CITY OF ALBUQUERQUE

RE: **Anthea – 4th and Granite NW**
330 Granite NW
Request 30 Day Temporary C.O. - Accepted
Engineers Stamp Date 9/12/14 (J14D171)
Certification Dated: 8/28/15

ANTHEA - 4TH AND GRANITE
ENGINEER'S CERTIFICATION (HYDROLOGY) FOR TEMPORARY CERTIFICATE OF OCCUPANCY

ANTHEA 4TH AND GRANITE
GRADING AND DRAINAGE PLAN
ALBUQUERQUE, NM
PROJECT #14-009

C-1.0

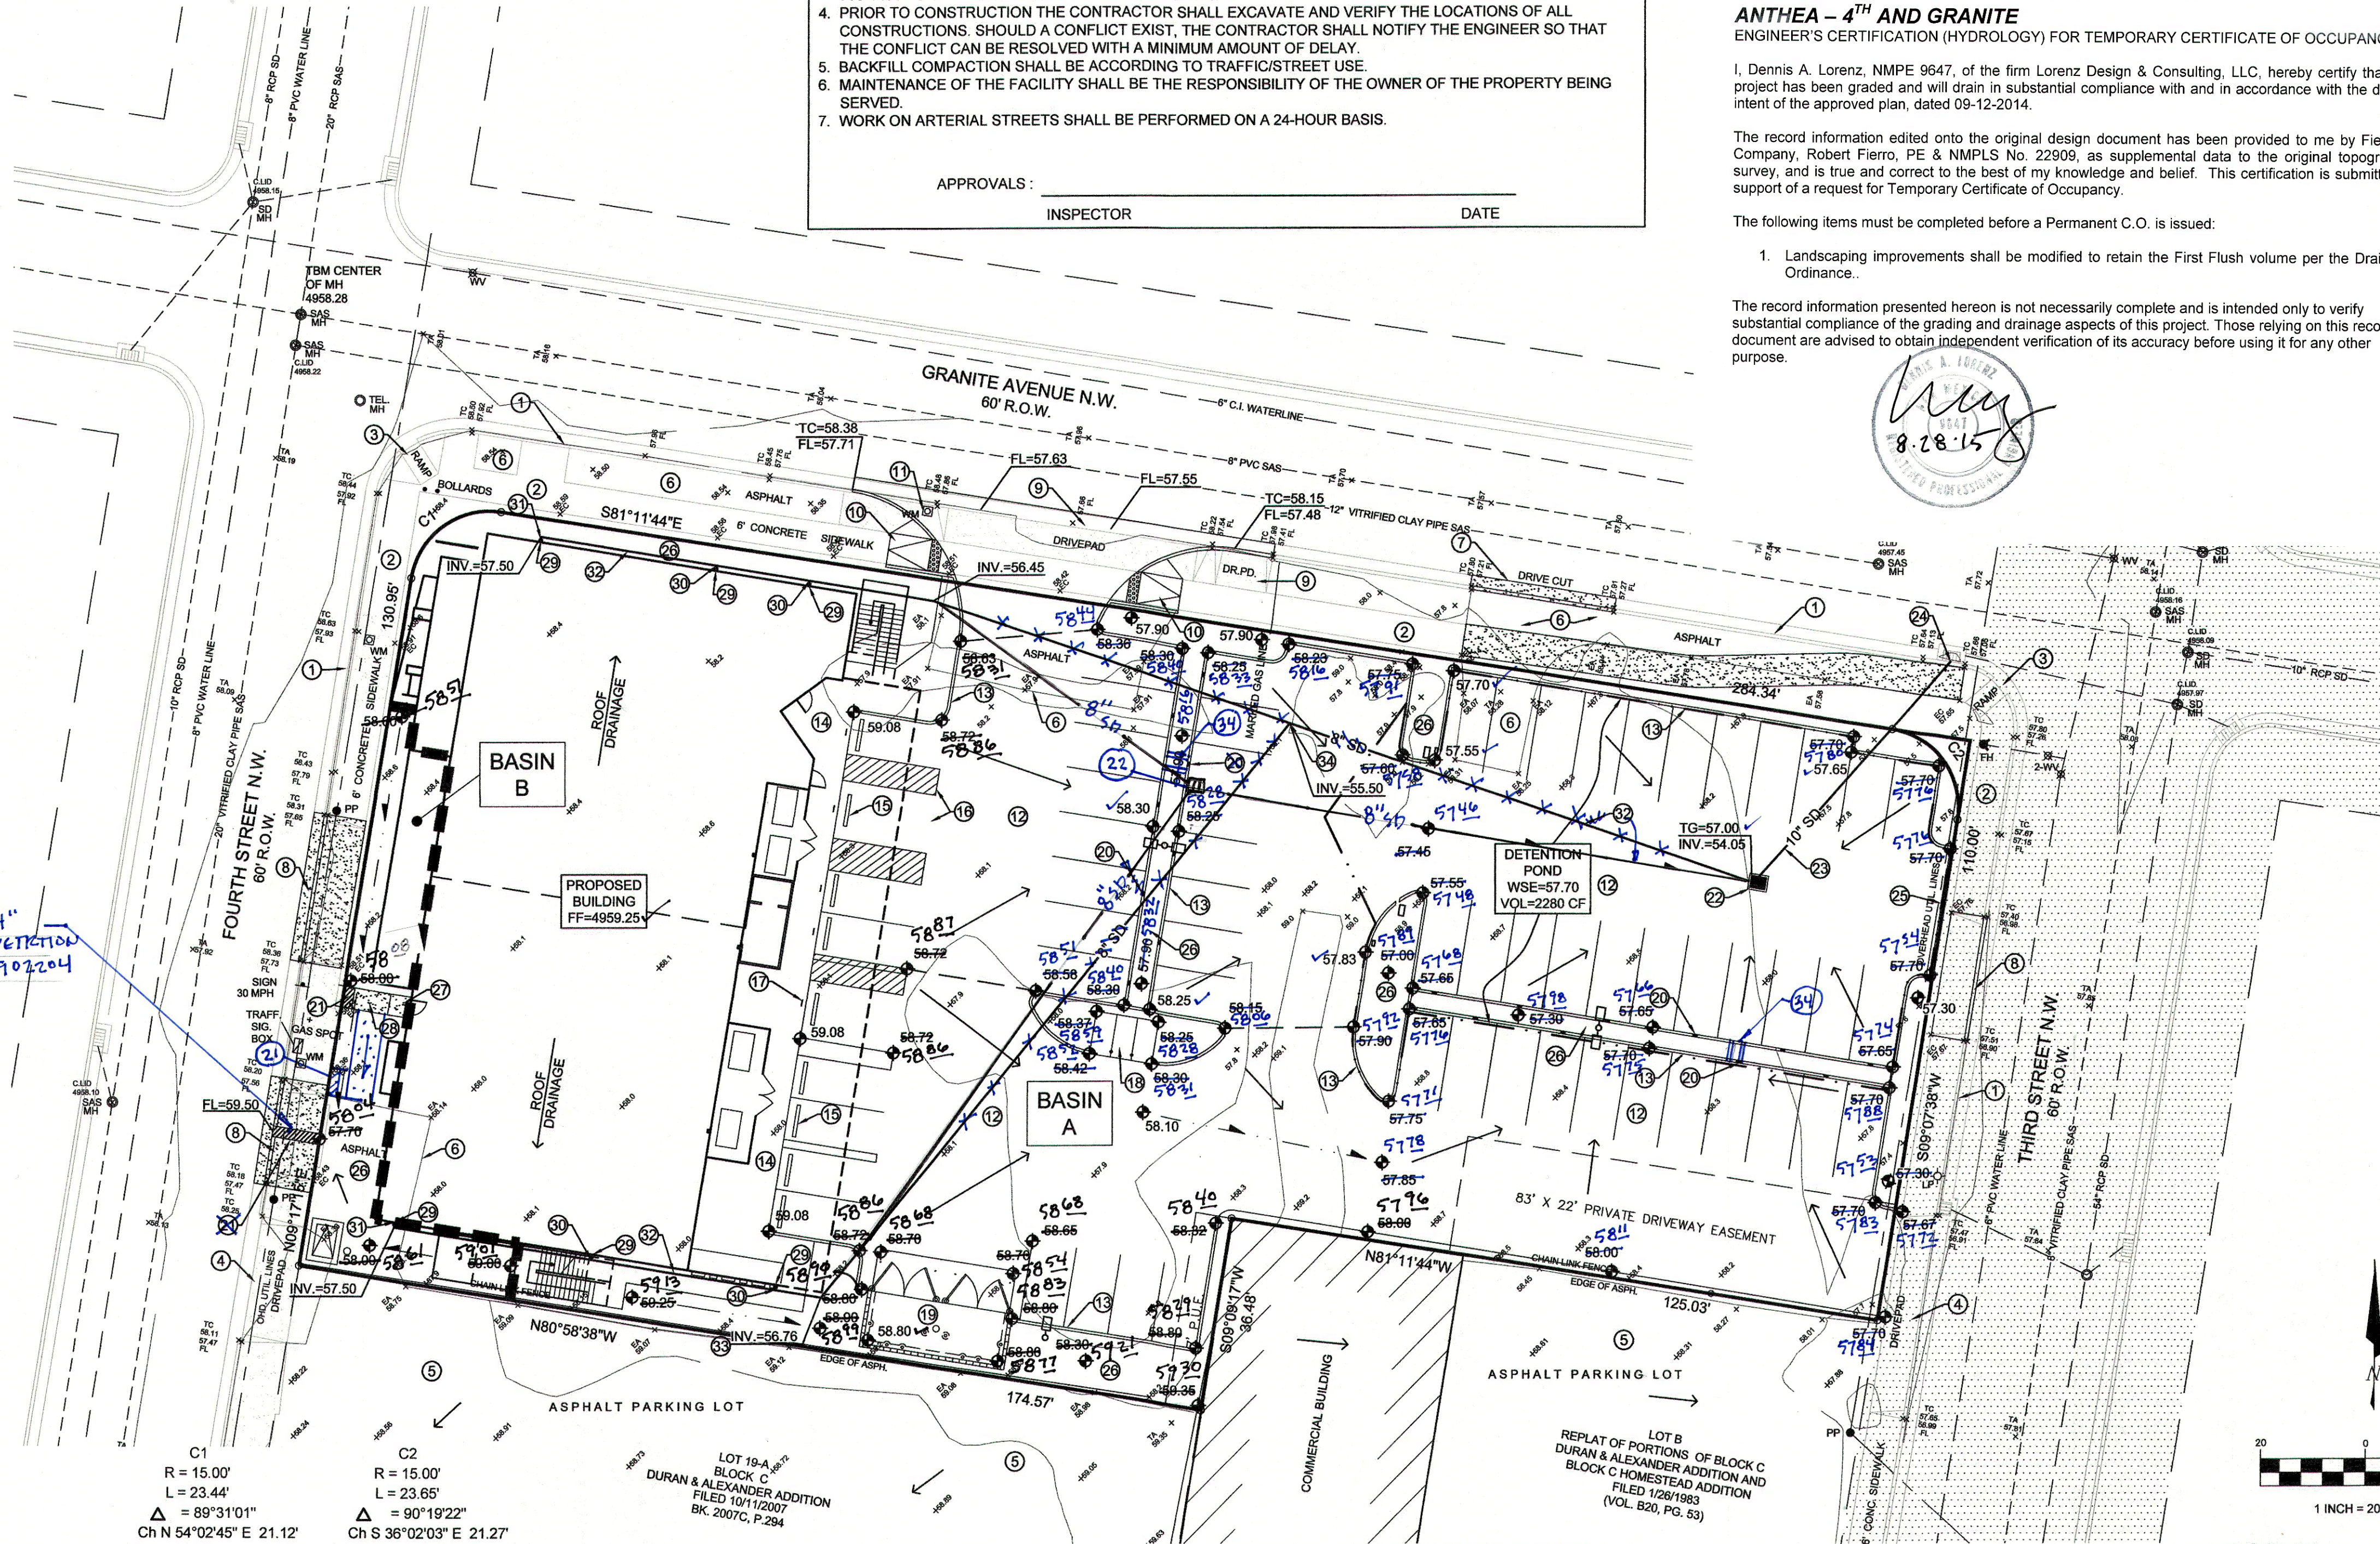
Based on the Certification received 8/31/2015, the site is acceptable for 30 Day Temporary release of Certificate of Occupancy by Hydrology.

The following items must be completed before a Permanent C.O. is issued:

- Landscaping improvements shall be modified to retain the First Flush volume per the Drainage Ordinance.
